Town of Arlington, MA Redevelopment Board

Agenda & Meeting Notice October 25, 2021

Docket #3665, 645 Massachusetts Avenue

Docket #3673, 455-457 Massachusetts Avenue

East Elevation - David Lamson Way

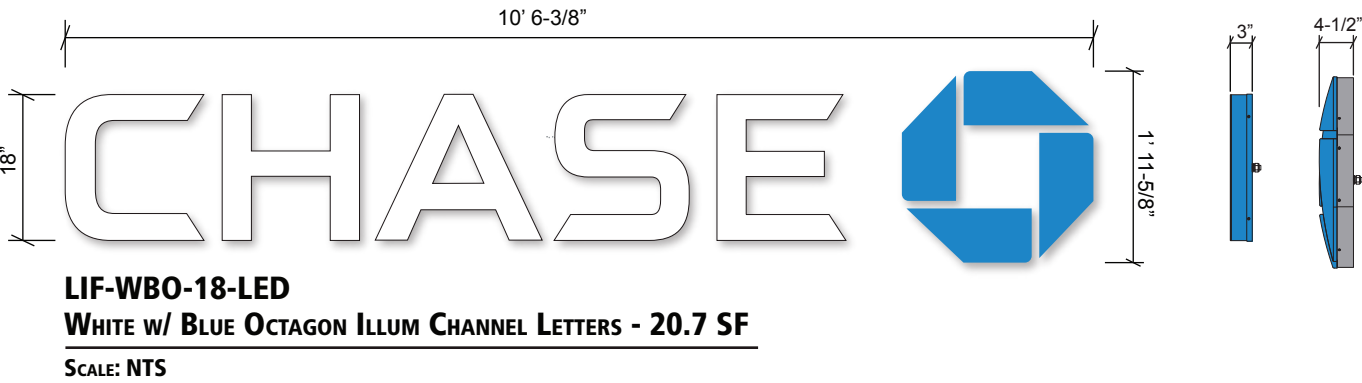
Regarding the windows along the Massachusetts Avenue and David Lamson Way facades, the renderings and elevations in the sign package show that the gridded windows will be replaced with commercial windows. It appears from the renderings that the glazing has also been addressed. Specifications on window type and glazing have not been provided.

The applicant proposes to eliminate the awning over the Mass Ave and David Lamson Way façades of the building which was added by the prior tenant. The presence of awnings along Mass Ave is desirable, as they provide shelter for pedestrians in

Façade: The board recommended changing the existing gridded windows to match the proposed new windows. THE RENDERINGS HAVE BEEN REVISED TO INCORPORATE THIS CHANGE

DRC Page 8

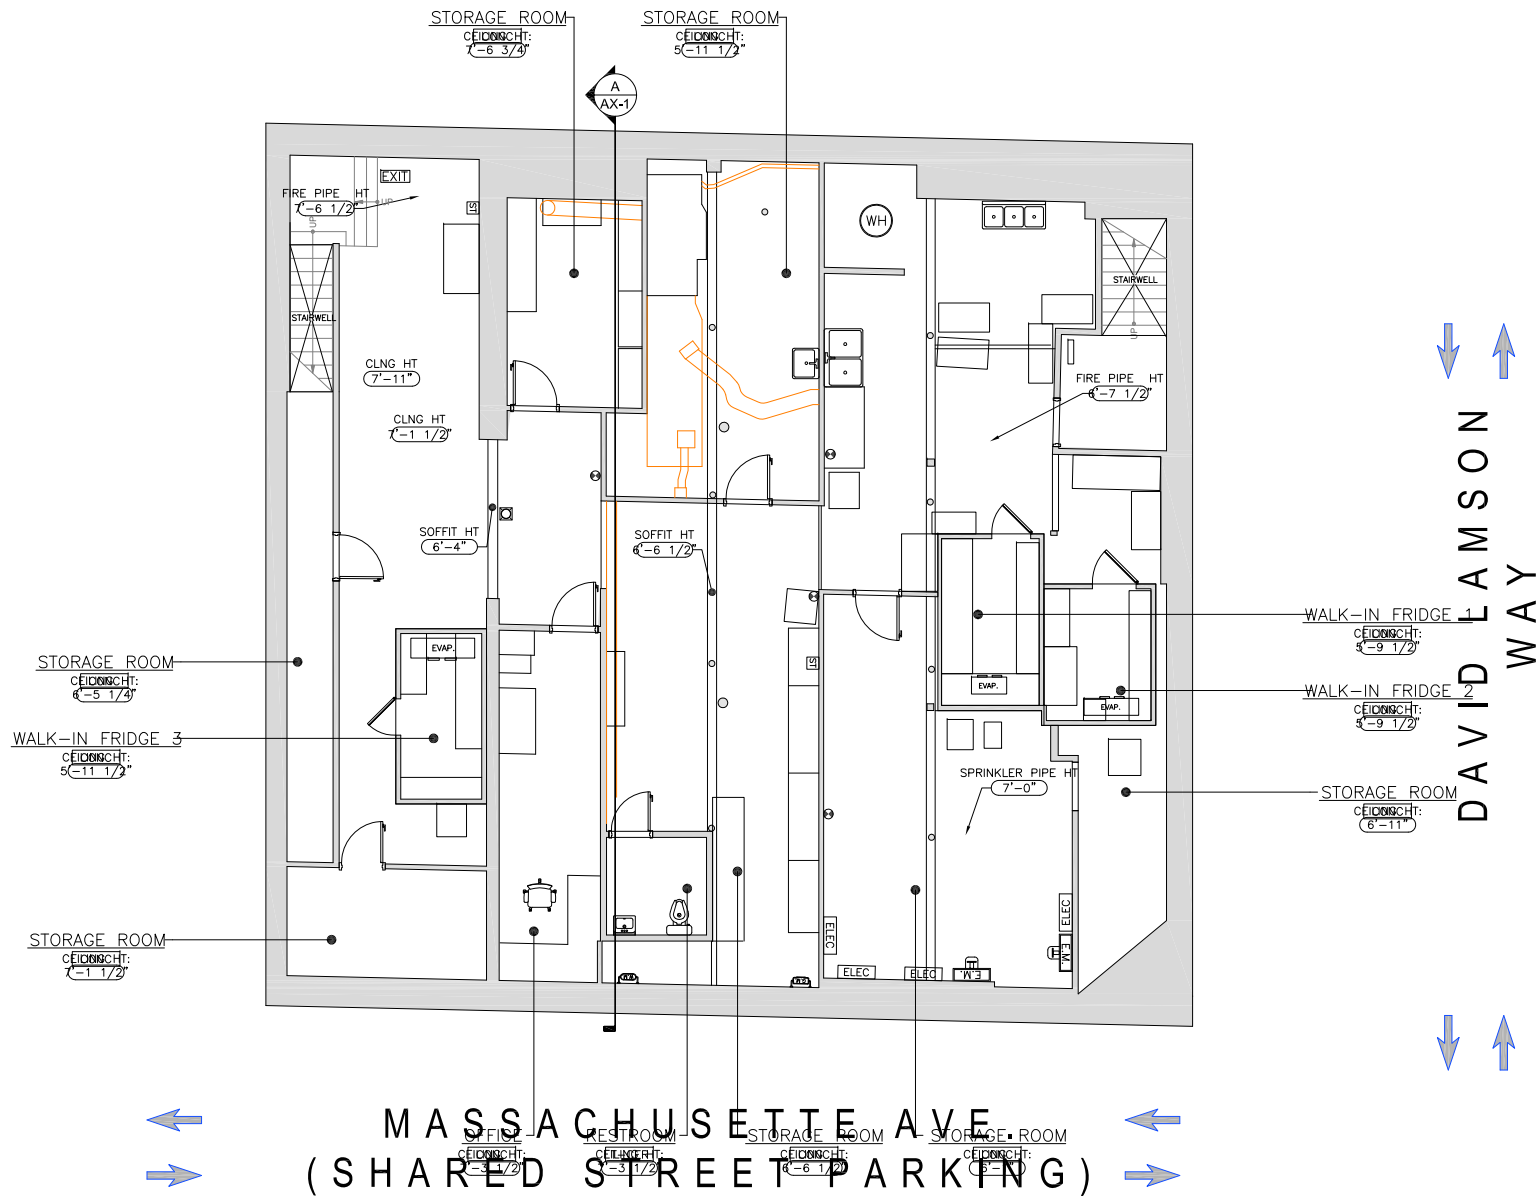
Regarding bicycle parking, the applicant states that submission materials have been updated to show short term bicycle parking in front of the site. A bicycle rack is shown on the rendering on DRC Page 8 of the updated sign package. The applicant should update site and/or floor plans accordingly, indicate the amount of short-term bicycle parking provided. While the applicant indicates that long-term parking will be integrated into the project, the applicant will need to provide updated floor plans identifying the location, quantity, and type of long-term bicycle parking. Bike rack specifications for short- and long-term parking are needed to determine compliance with Section 6.1.12.E.

The applicant should confirm that the “proposed new storefront” callout along David Lamson Way on floor plans on DRC pages 7 and 8 refer to the new commercial windows and not operable service windows.
